RHODE ISLAND ATOMIC ENERGY COMMISSION

License R-95
Docket No. 50-193

This letter provides answers to your letter of August 3, 1995 concerning a revision of the Rhode Island Nuclear Science Center Technical Specifications to combine the Radiation Safety Committee and the Reactor Utilization Committee into a single committee called the Nuclear and Radiation Safety Committee (NRSC).

TECHNICAL SPECIFICATIONS
Rhode Island Nuclear Science Center
Docket 50-193, License R-95
Revision 1

FIGURE 6.1
RINSC Organizational Chart

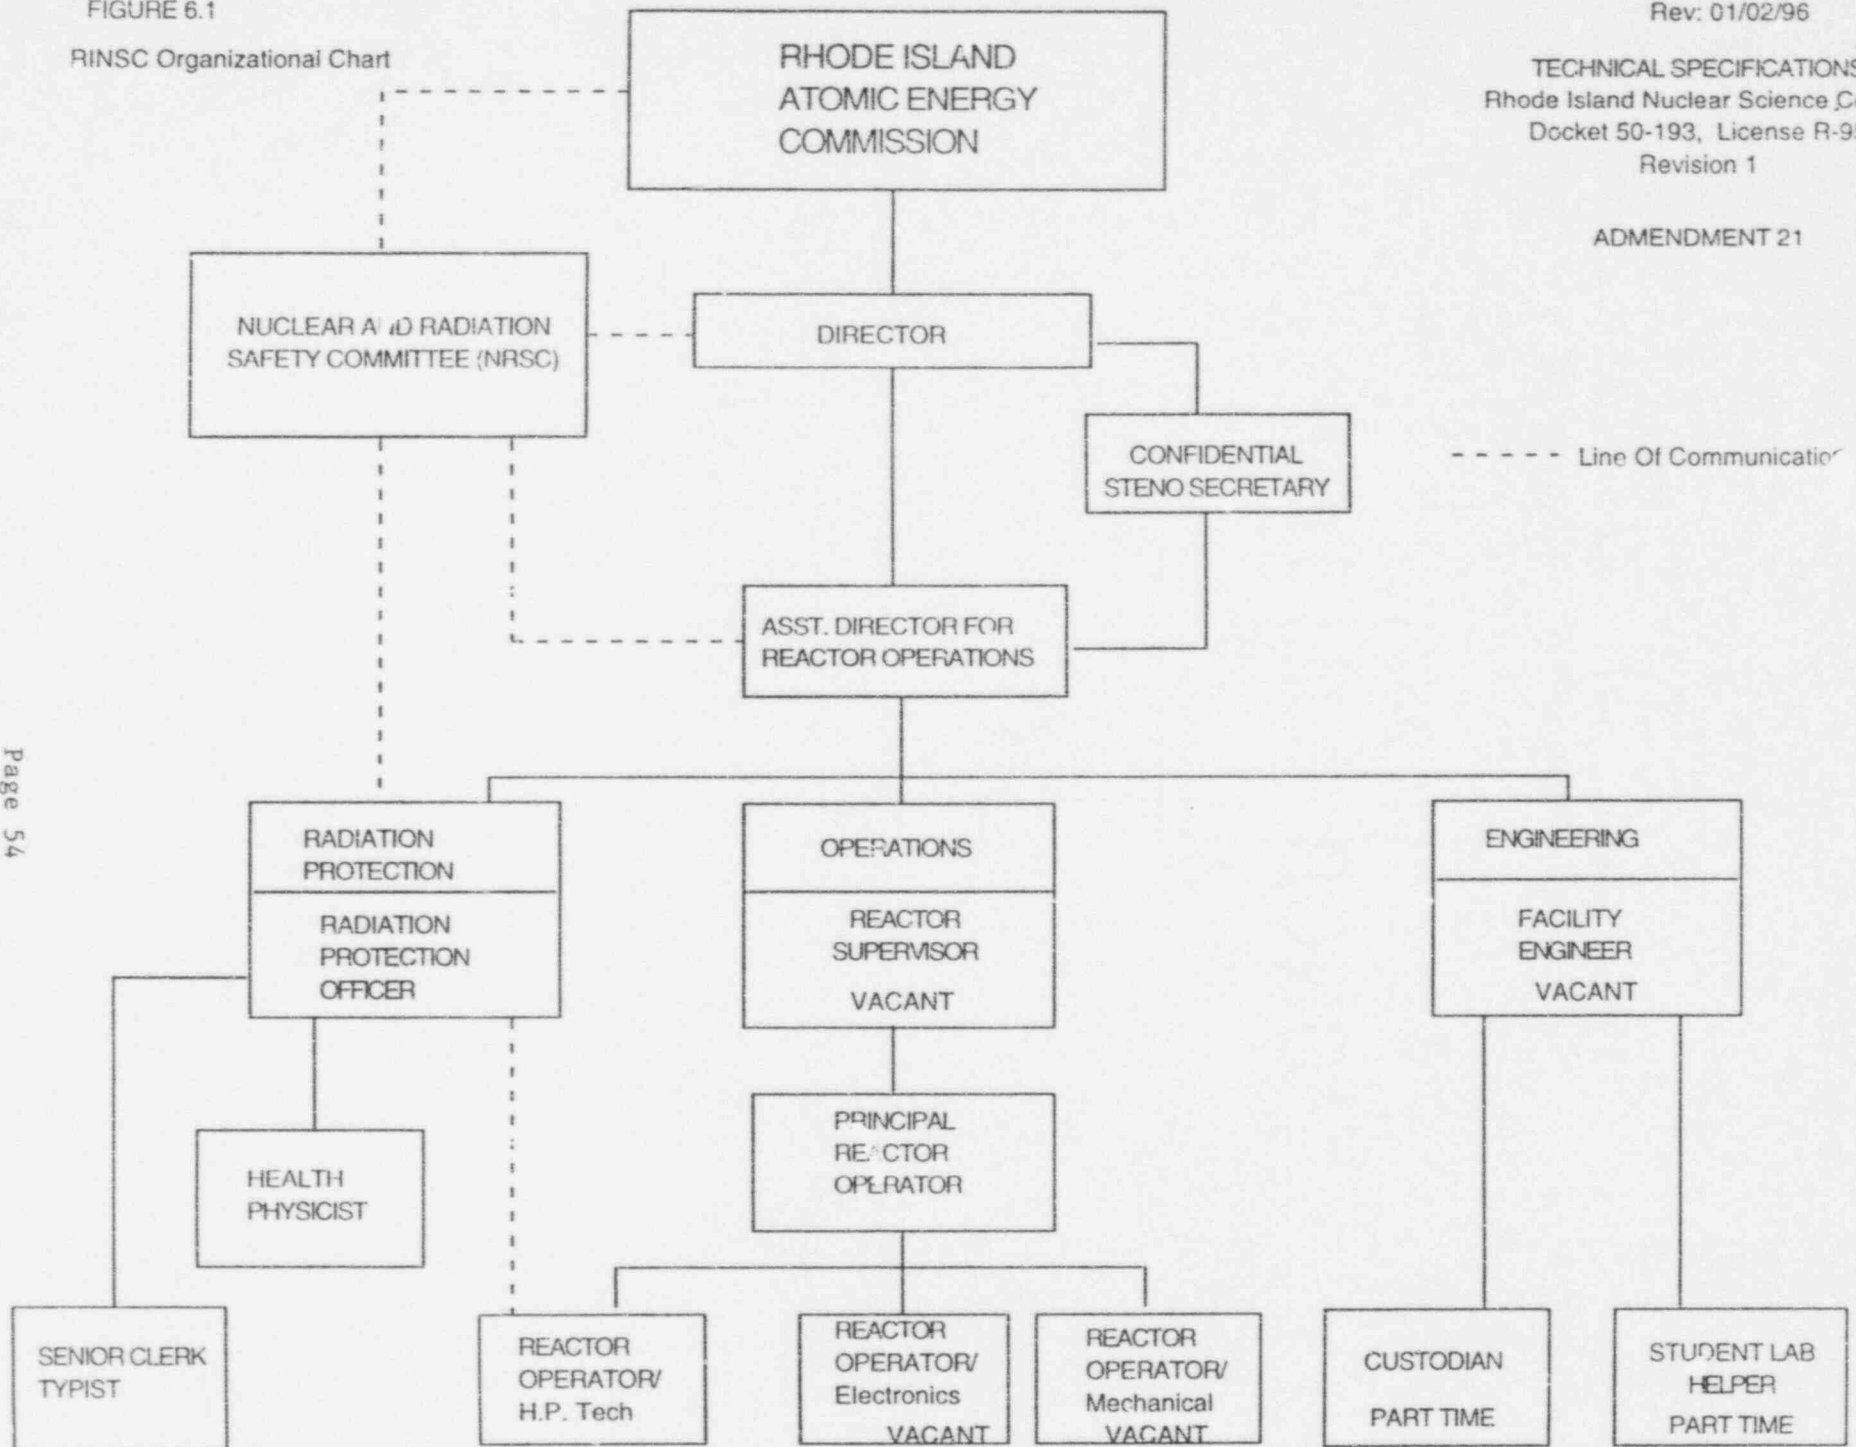
Figure 6-1 has been revised to reflect the revisions to the name and composition of the committees shown on the organizational chart.
